**Attachment 7**

Correspondence with USEPA

**From:** Santos.Carmen@epamail.epa.gov [mailto:Santos.Carmen@epamail.epa.gov]  
**Sent:** Tuesday, October 13, 2009 3:10 PM  
**To:** Goloubow, Ron  
**Cc:** Wilson.Patrick@epamail.epa.gov; Santos.Carmen@epamail.epa.gov  
**Subject:** PCBs at Aspire Property (66th Avenue, Oakland, CA)  
**Importance:** High

**Building Materials Sampling Plan  
Former Pacific Electric Motors Facility  
1009 66<sup>th</sup> Avenue in Oakland, California**

Figures 1 and 2

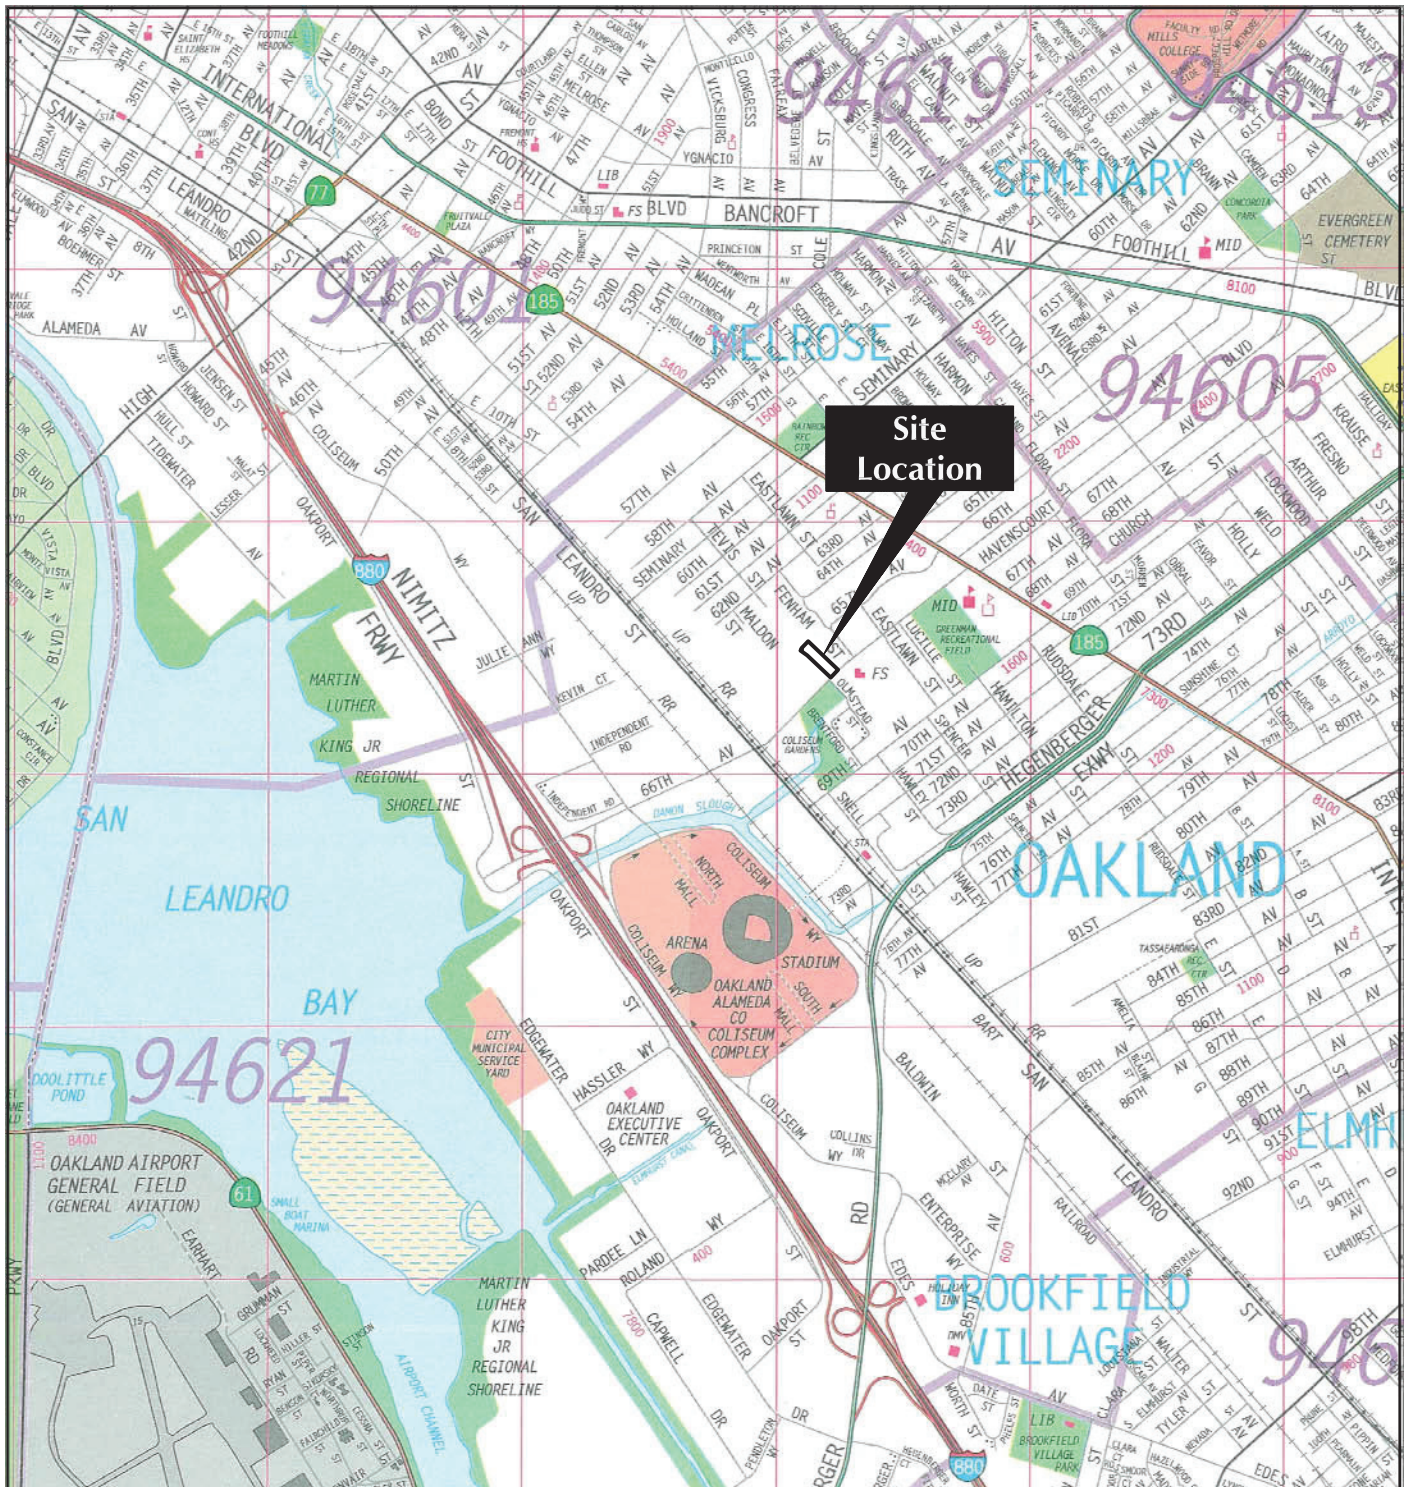
Analytical results of soil samples collected from soil boring 4B located in proposed excavation area PCB-EXC1, contained PCBs at a concentration of greater than 50 mg/kg (see Figure 2). Based on these analytical results, soil excavated from this area will be transported off-site and disposed of at Waste Management's Kettleman Hills Landfill.

Analytical results of soil samples collected from soil borings located in proposed excavation areas PCB-EXC2, PCB-EXC3, and PCB-EXC4 of the Site contained PCBs at a concentration of less than 50 mg/kg (see Figure 2). Based on these analytical results, this soil will be transported off-site and disposed of at Republic Services' Vasco Road Landfill located in Livermore, California.

Field staff will obtain and document total dust readings from the mini-RAM throughout each work day when affected soil excavation activities are occurring on the Site. These readings will be obtained from air monitoring stations established along the Site's perimeters (a total of 5 stations; see Figure 2).

In addition to monitoring for total dust using at least four fixed air monitors, equipped with a mini-RAM, Personal Air Monitors (PAMs) used to collect air samples. The air samples will be collected on cassettes (media) that will be submitted to a laboratory for analysis of PCBs, arsenic, lead, and benzene. The air samples will be collected each work day when affected soil excavation activities and site demolition activities are occurring on the Site. Air monitoring stations will be at locations illustrated on Figure 2 (attached).

Figure 1 – Site Vicinity Map  
Figure 2 – Proposed Pavement Plan

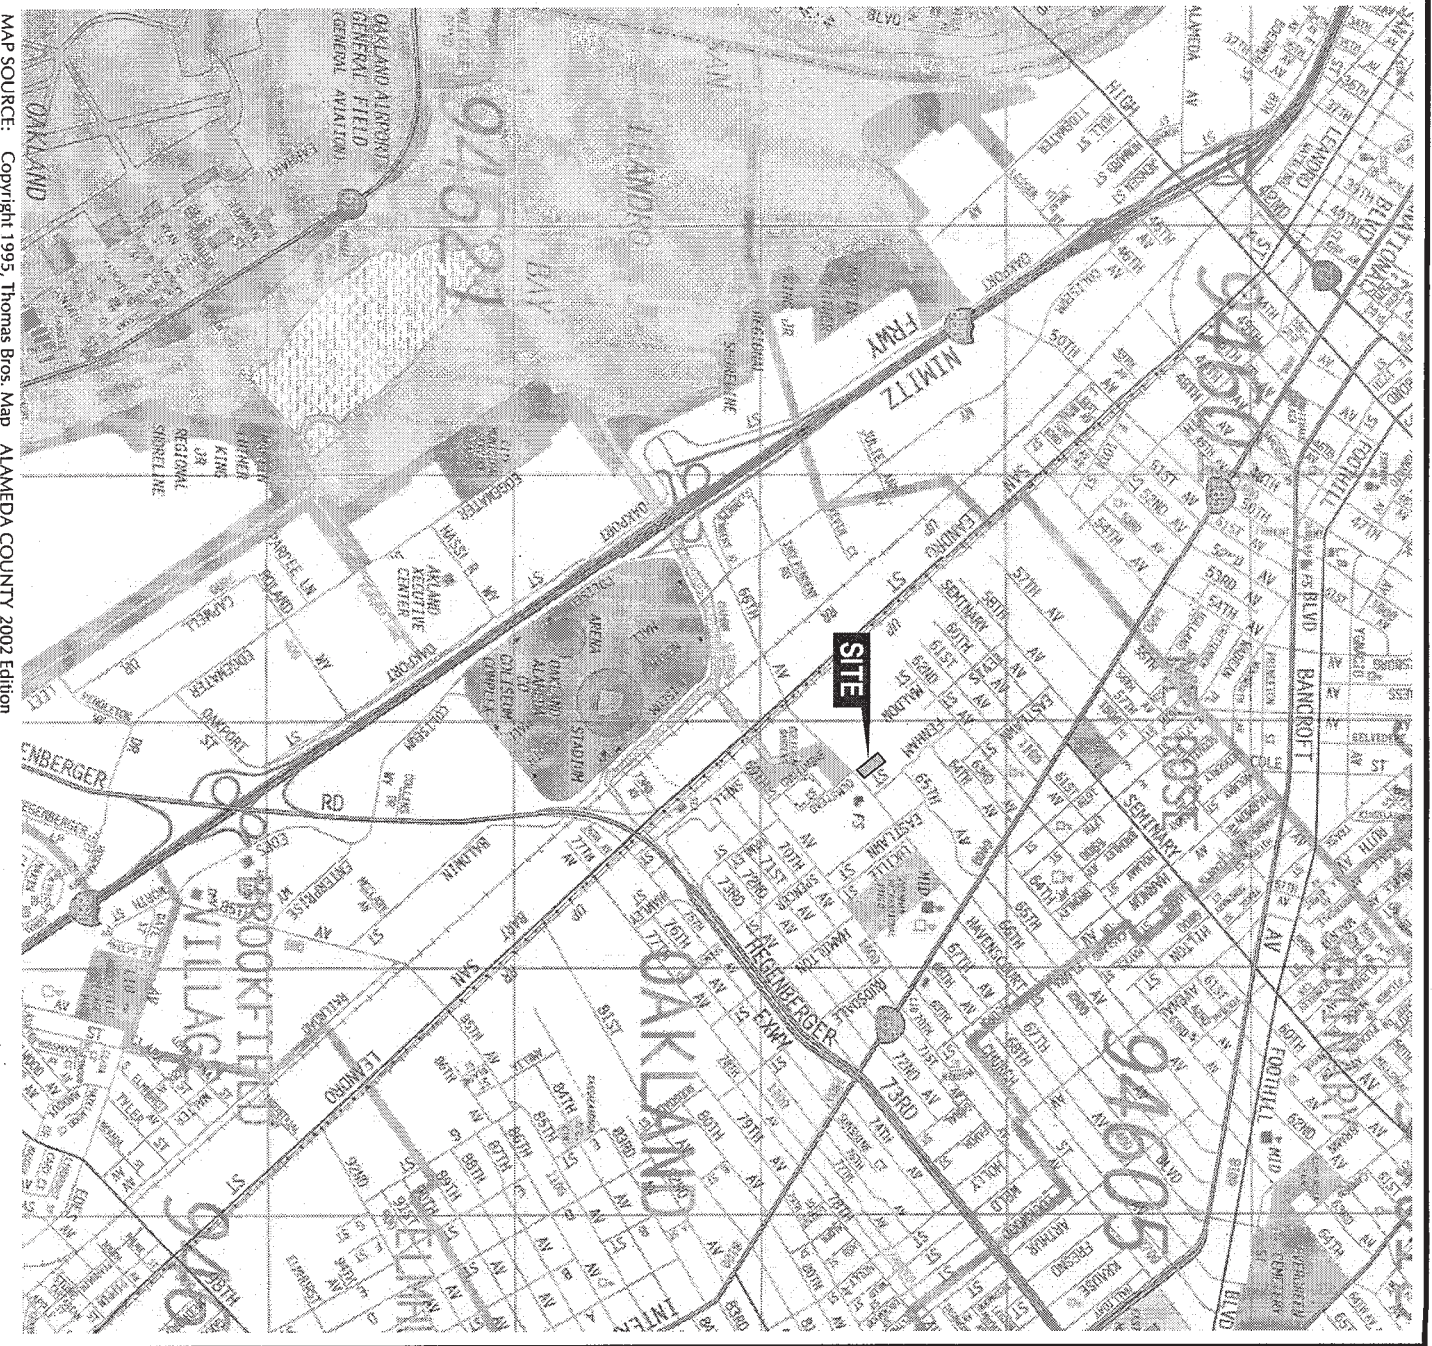
The additional cap modifications proposed in the attached Arcadis' April 25, 2011 letter and described in Figure 2 (Proposed Pavement Plan) of that letter differ from the cap requirements in 40

CFR 761.61(a)(7) and include landscape areas. Figure 2 also describes the soils that will be used to construct the proposed landscape areas; and those areas were not a feature of the original site-wide cap proposed in the October 2009 Notification consistent with the cap requirements in 40 CFR 761.61(a)(7).

Within 10 days after Arcadis' receipt of the laboratory analytical results for the imported soil samples, please submit the laboratory analysis results to USEPA for review before imported soils are placed in the landscape areas designated in Figure 2 of the attached Arcadis' letter. This data must also be provided to ACDEH.

The details regarding the proposed pavement design for the Site is illustrated on Figure 2. As illustrated there are six different designs for pavement thicknesses depended upon the specific traffic - Site use in the area.
